Water-Suply.- Deferring for the present,,the consideration of the proposals recommended by the Sanitary Board for carrying out the filtering portion of the scheme for which estimates were called for in G.O. No. 1311M. dated 12-8-95, and stating that the Sanitary Board should direct their officers to de~~n~~vote their attention to the drainage of Cuddapah.

CUDDAPPAH WATER SUPPLY SCHE

Cuddapah water supply

Report regarding Cuddapah Filter Beds.

WORK TO BE DONE IS COLOURED YELLOW.

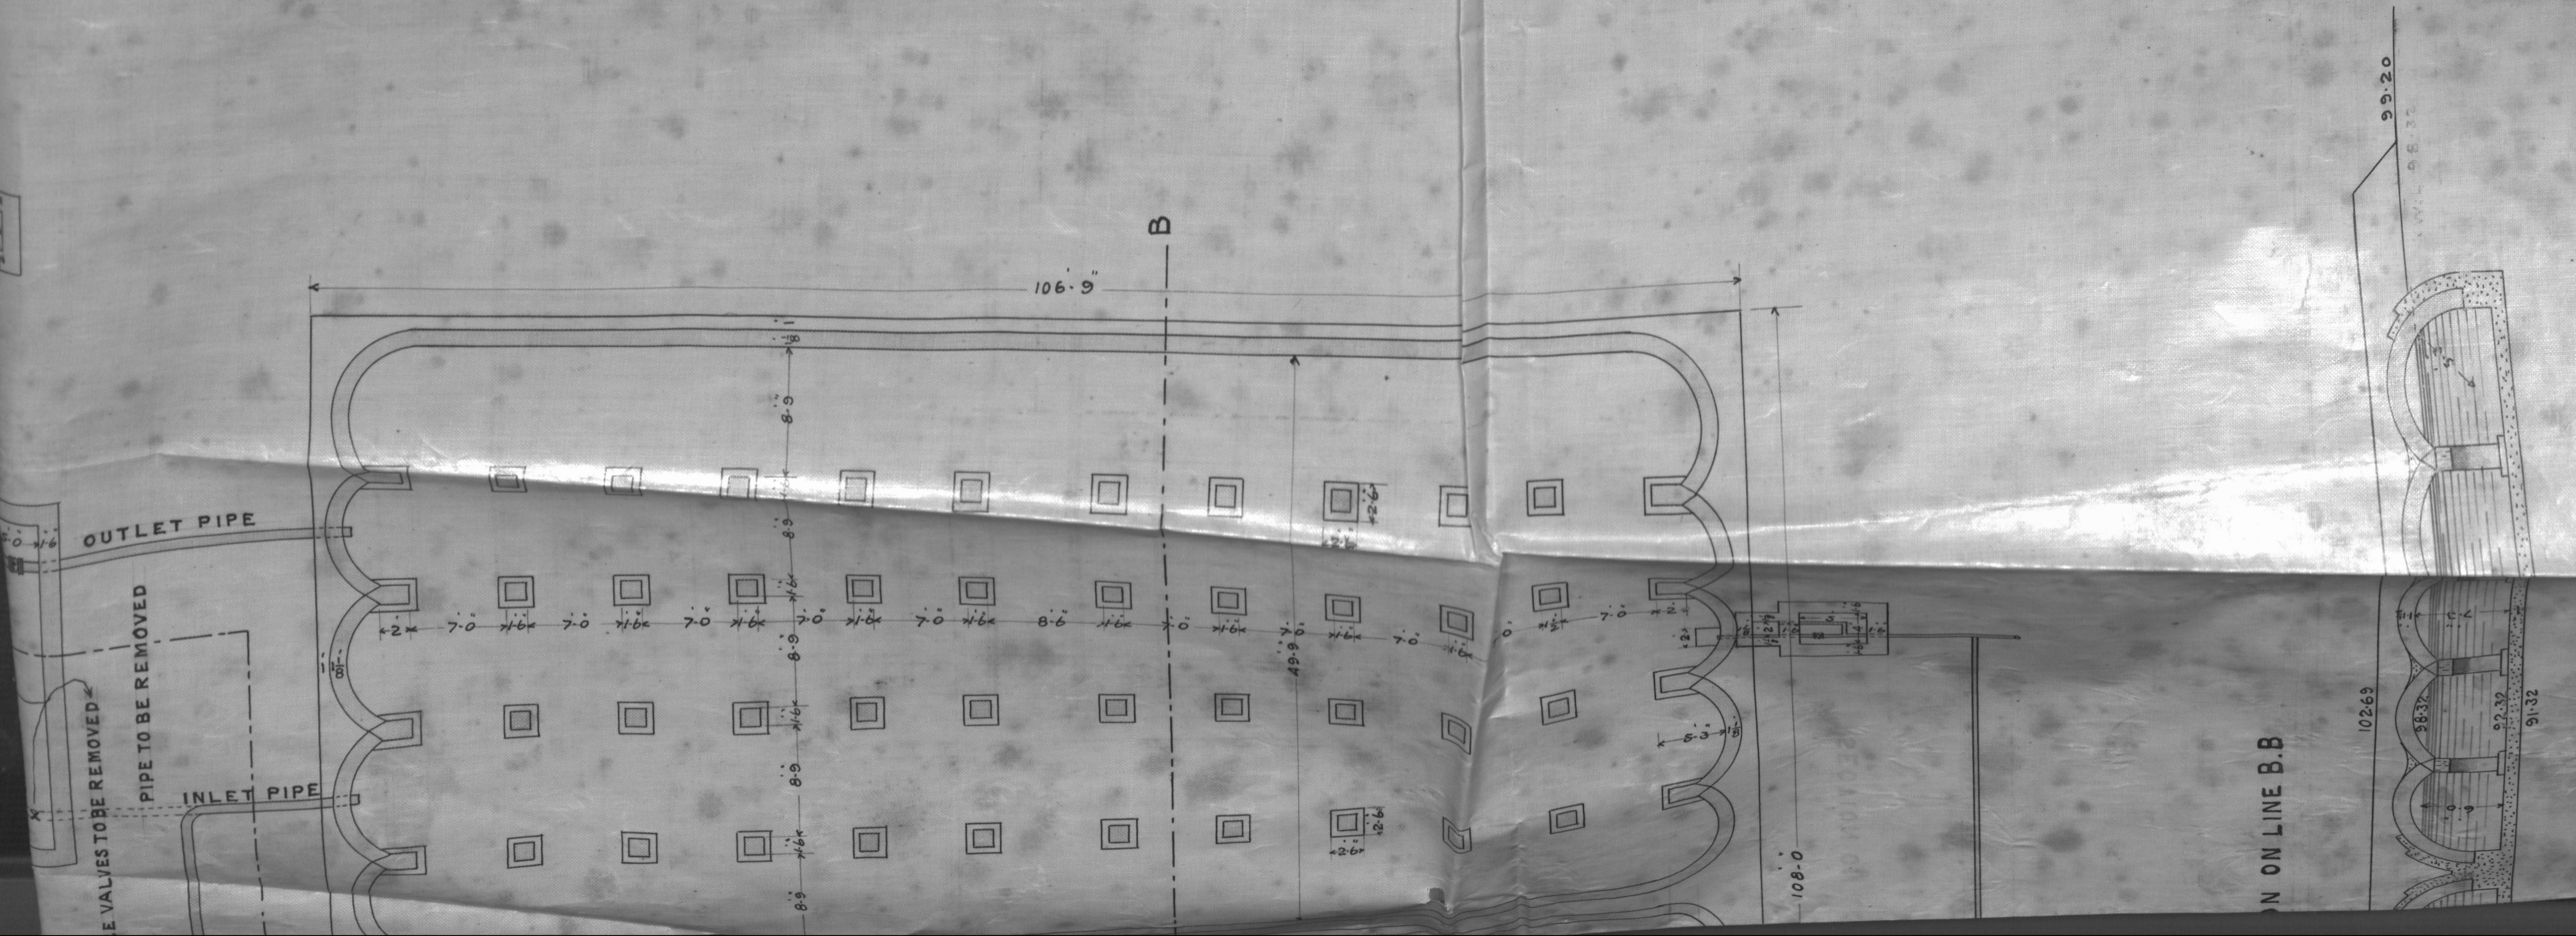
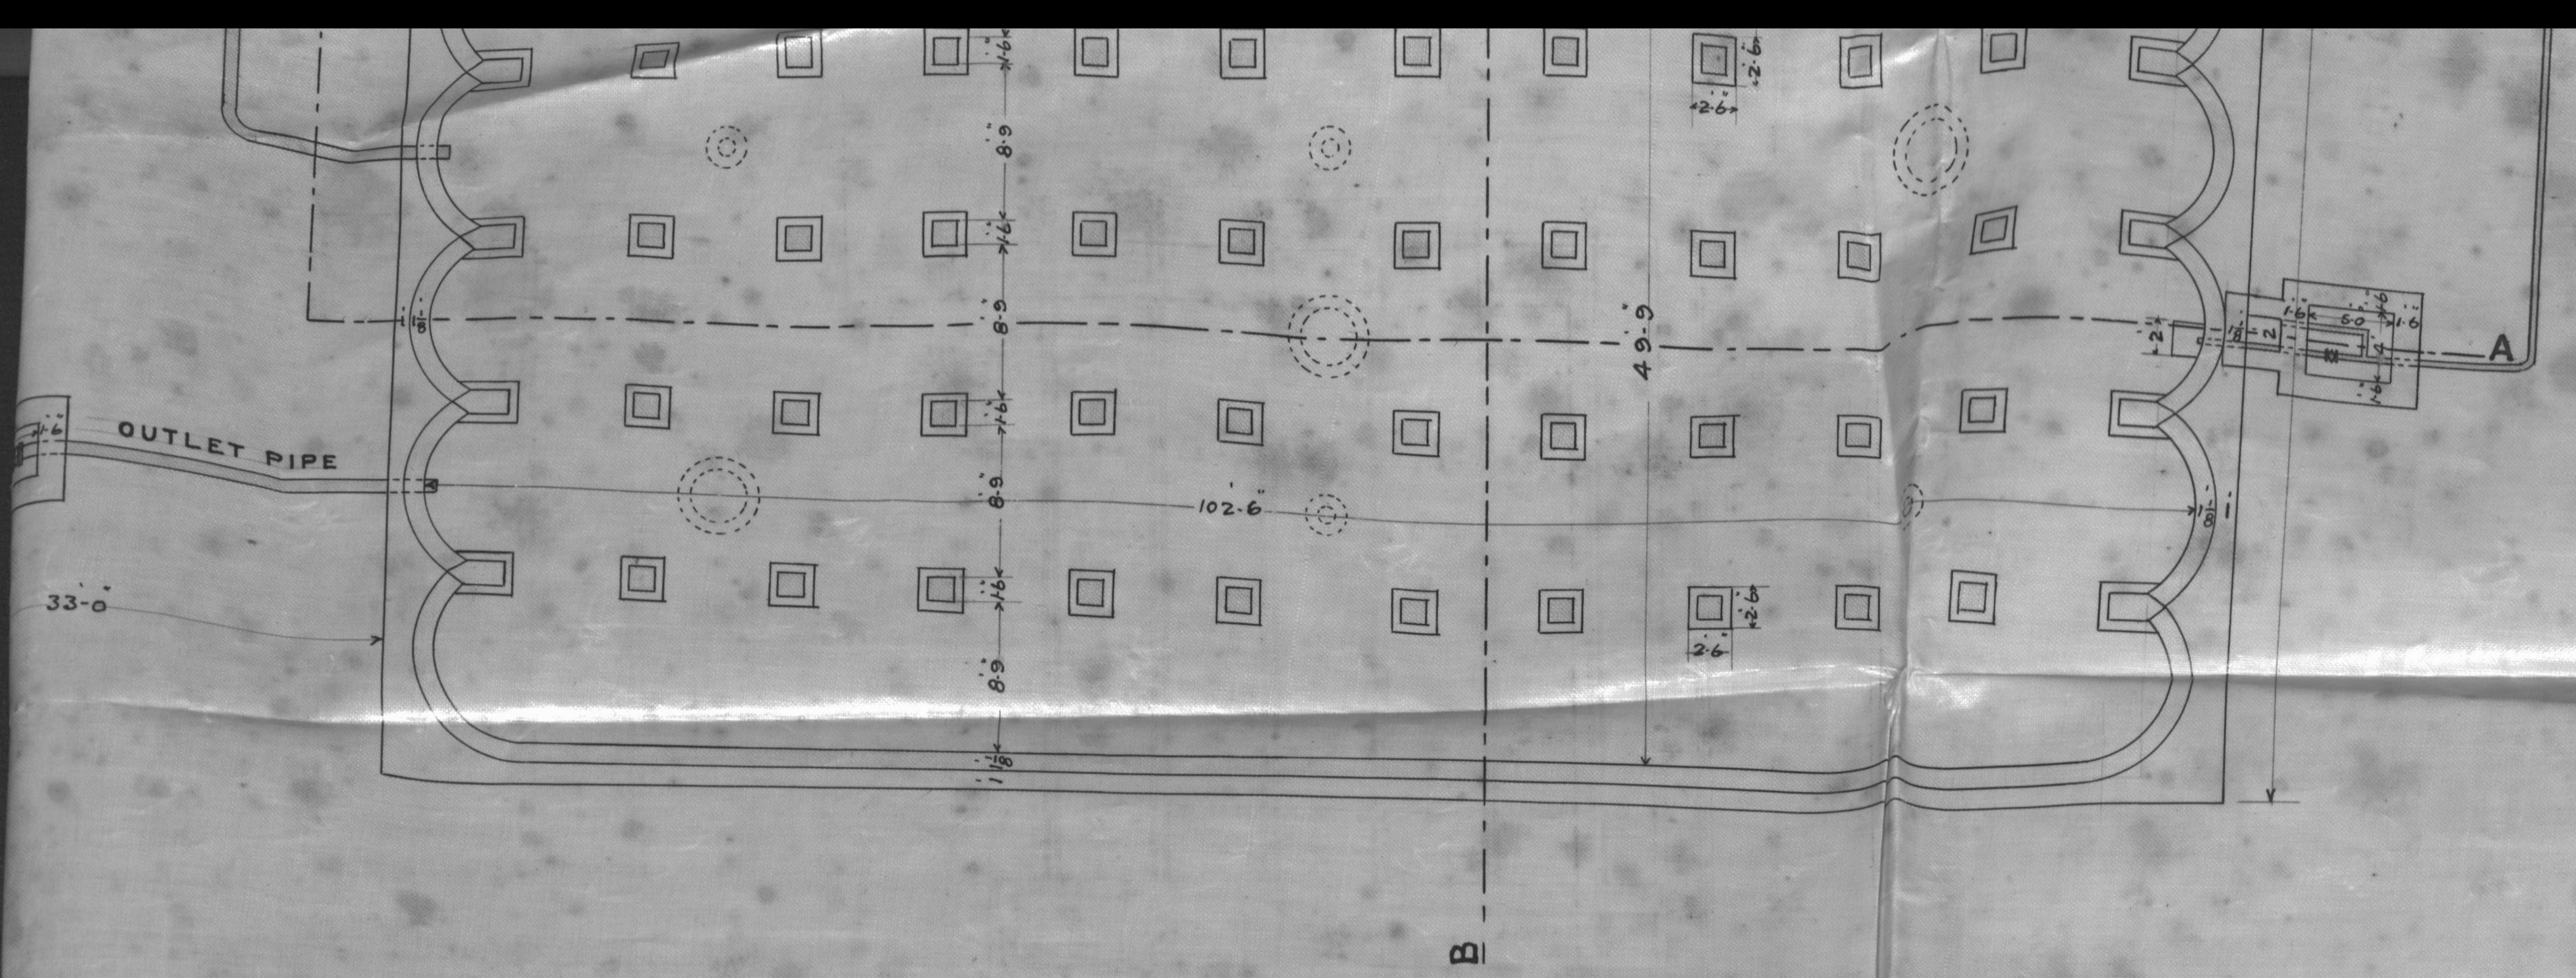
This is an estimate to carry out recommendation (5) of the San. Bd.: page 2 G.O. 12th Augt. 95 no. 1311 L. & M., by ~~supplying~~ ^providing^ filter beds to the existing water supply, & is a measure wh. shd. in any case be carried out for the benefit of the inhabitants. There seems no need to defer it. The estimates may be sanctioned & orders given to commence the work

I wd. not sanction this estt. at present. The water supply comes from a distant point at which, so far as I know, there is no malaria. No doubt filtering is a good thing, but I am of opinion that the urgent matter is the drainage. If that fails we may try filtering. But even then the Sanitarians should demonstrate that the plasmodium malariæ exists in the water. This they have not attempted to do. We cannot afford to spend Rs 33600 on the mere chance that it may so exist. I am surprised that they should have taken up this secondary question now instead of devoting their whole energy to the much more important & primary question of the drainage.

Order. The Govt. will defer for the present the consideration ~~construction~~ of the proposals ~~works~~ recommended by the Sanitary Board ~~can-~~ for carrying out the filtering portion of the ~~not be sanctioned at present as the~~ scheme for which ests. were called for in G.O. 12 Aug. 95 No 1341 ~~Government is not satisfied that malaria~~ It has not been shown that ~~germs are to be found in~~ the water-supply, which comes from a distant point, is infected with malarial germs. Evidence ~~It is to be regretted that the~~ on this point shd. be procured & laid before Govt. H.E. the Govr. moreover considers that the primary & more urgent portion of the scheme is that relating to the drainage, to which the Sanitary Board shd. direct their officers to devote their earliest & most earnest attention.
